SUBJECT: RESPONSE TO INEL REQUEST FOR SPES-2 INFORMATION/
CLARIFICATION - MGO-29-93

This letter responds to a request for information on the AP600 SPES-2 test facility received in a letter dated June 28, 1993 from Mr. Ortiz of the Idaho National Engineering Laboratory (INEL). Attachment 1 provides written responses to the information requested by INEL. Attachment 2 identifies two reports prepared by SIET for the SPES facility which provide supplemental data requested by INEL. These reports are provided as an enclosure to this letter.

Attachment 1 to Westinghouse Letter ET-NRC-93-3943
Response to INEL Request for SPES-2 Information/Clarification -
MGO-29-93

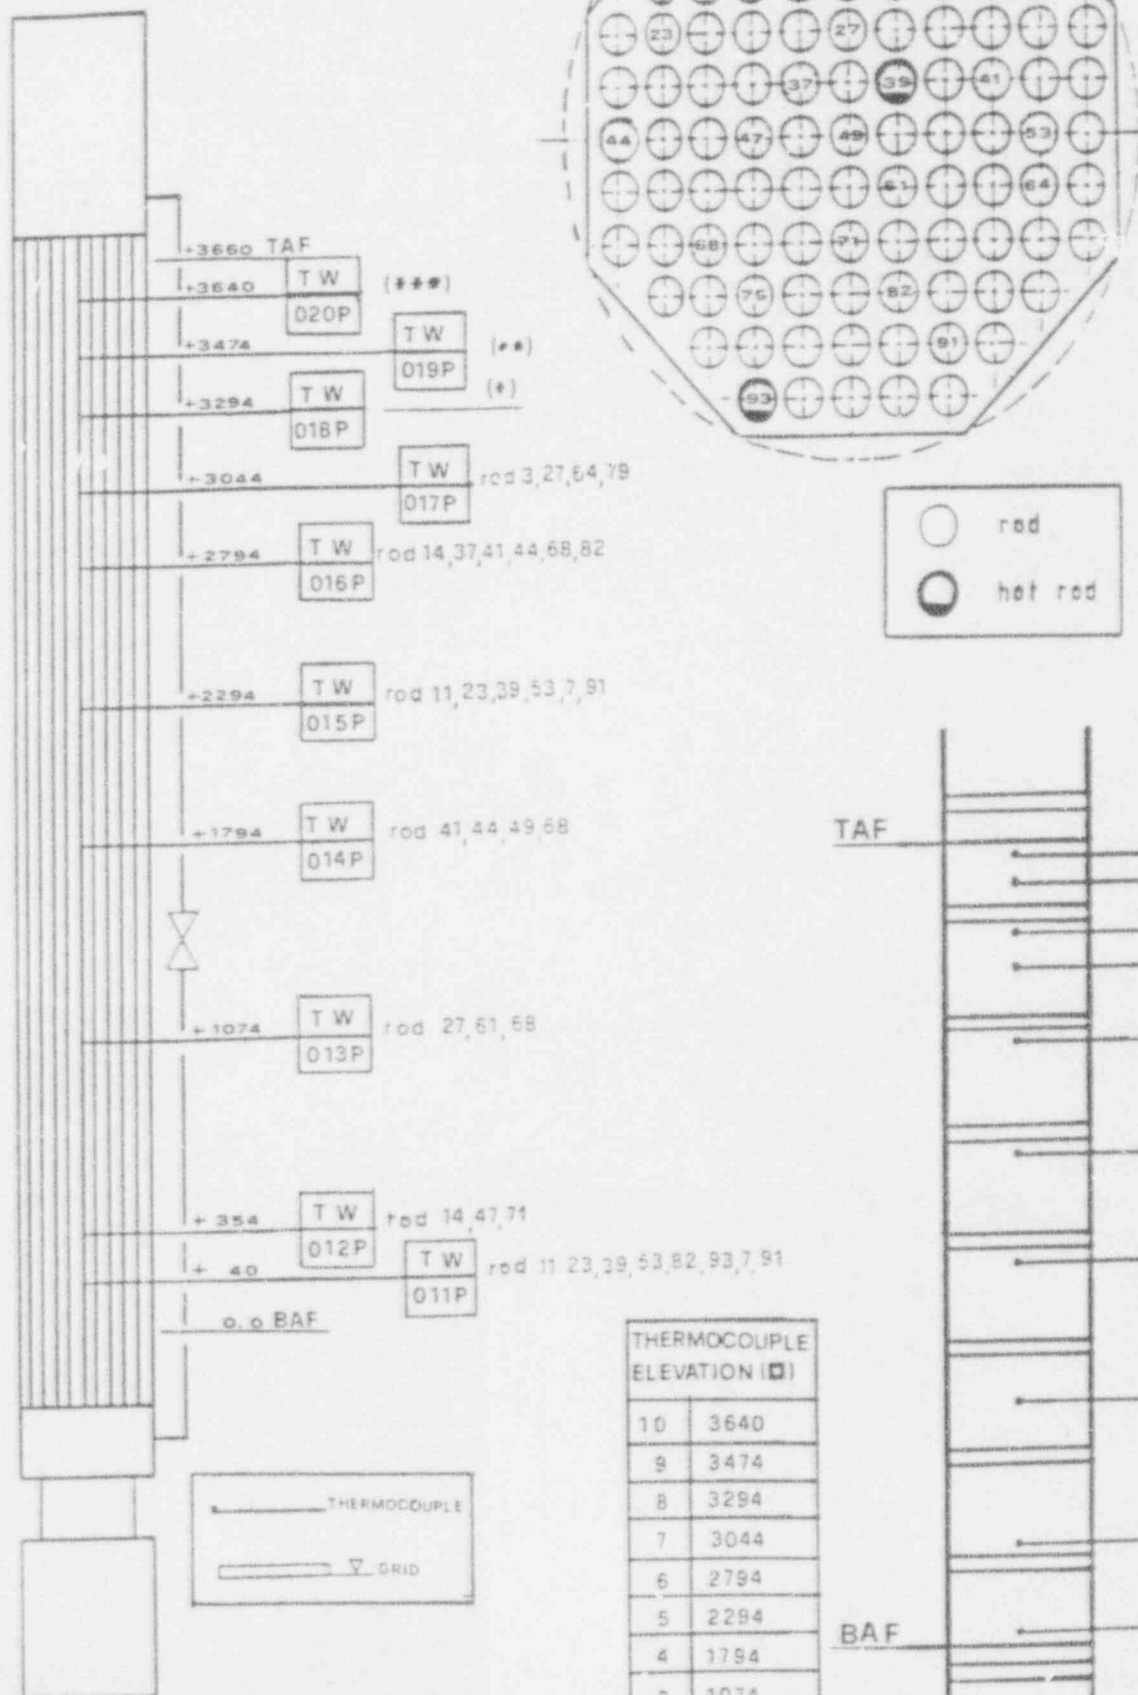
- 3.1 How many rod bundle spacers are there in the power channel, and what is their elevation with respect to the bottom of the active fuel?

Reference 11, Figure 3.3.2/2 illustrates a rod bundle spacer. However, we have no information that specifically shows their location in the power channel.

There are 11 grid spacers in SPES-2, seven of which are in the heated rod section. The actual, as installed grid locations, referenced from the bottom of the heated portion of the rod to the bottom of the grid are:

3829, 3327, 2825, 2325, 1825, 1322, 827, 325, -33, -666, and -1363 mm's.

Attached is a revised drawing of the grid.

SIET	Document	Rev	Page	of
Sez. Reattori Innovativi	00182PO92	0	55	80

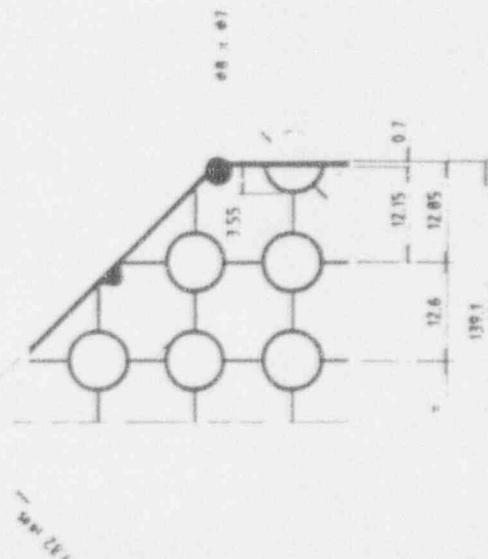
1.2 There are 97 rods. How many are "hot"? Where are they located in the core?

If there are two types of rods, we may separate the core region into two separate channels. To do this we need to know how many "hot" rods there are and where they are located.

There are two (2) hot rods in rod positions 39 and 93 as shown in the attached figure.
